NOTIFICATION - Jan 08 2020

Door upgrade

Chris Heintz (CH) STOL and CRUZER CH750

Photo shows a broken fibreglass door frame.

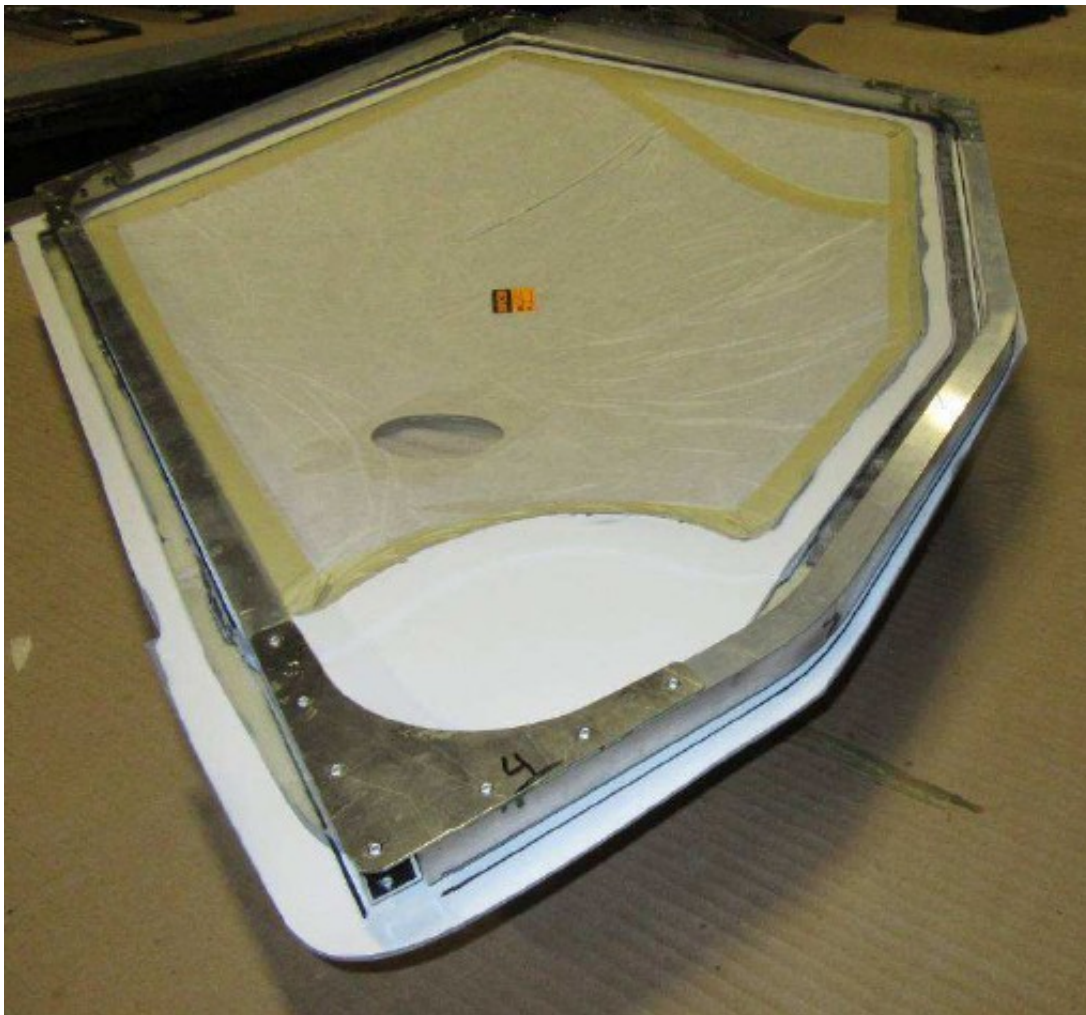
The original STOL CH750 SLSA uses a fibreglass framed door systems for pilot and co-pilot. There continues to be reports of doors cracking in flight on the STOL and Cruiser CH750's.

The original fiberglass door window is the same except that the new door has an aluminum frame, making the door stiffer.

Or you can modify your existing fiberglass doors by adding the aluminum frames and new latch/handle system.

Aircraft owners are encouraged to upgrading to the latest door design within the next 25 hours or sooner if cracks or damage is noticed or if the doors do not close properly.

If you have the original fiberglass doors, you can remove them completely and replace with the new aluminum framed doors.

When keeping the fiberglass doors and adding the aluminum frame, also view pages 8 and 9 of photo guide C75-NA-1 Section 4 . Upgrade the door frames and everything else as per the STOL CH750 drawings, revision 4. Pages 75-N-1, 75-N-2 and 75-NA-1 and 65-NA-2. Use the Zenair drawings, the photo guides and the Zenair Construction Standards Manual and or FAA 43.13-2A (Aircraft Inspection and Repair).
